LiDAR Quality Assessment Report

OK-FEMA_Pottawatomie-2011

v13 Spec Lidar - 2.0m NPS

FEMA Region VI - Lower Pottawatomie

Bridge removal error @ 35° 29' 34.6400" N, 97° 11' 19.9923" W

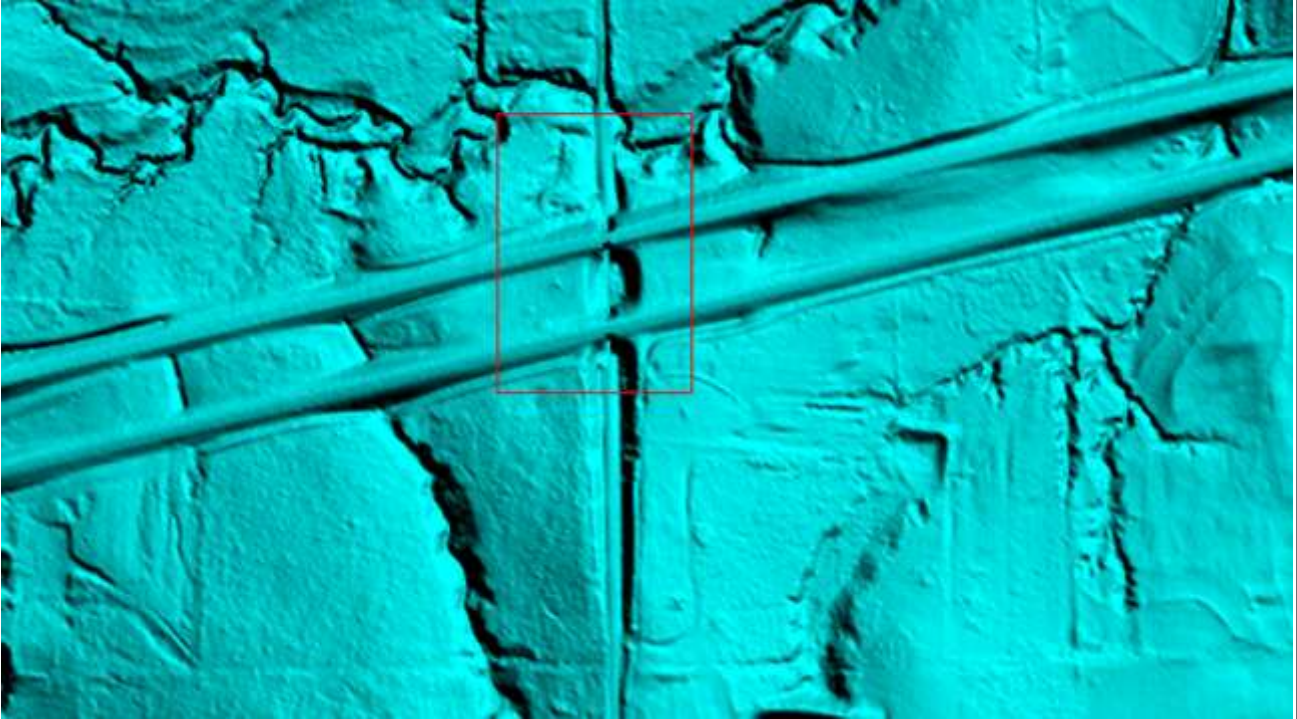
Several bridge and culvert removal errors were found in the DEM. Two examples of each are shown below, and the rest have been listed with their respective coordinates.

This error has been fixed by the vendor.
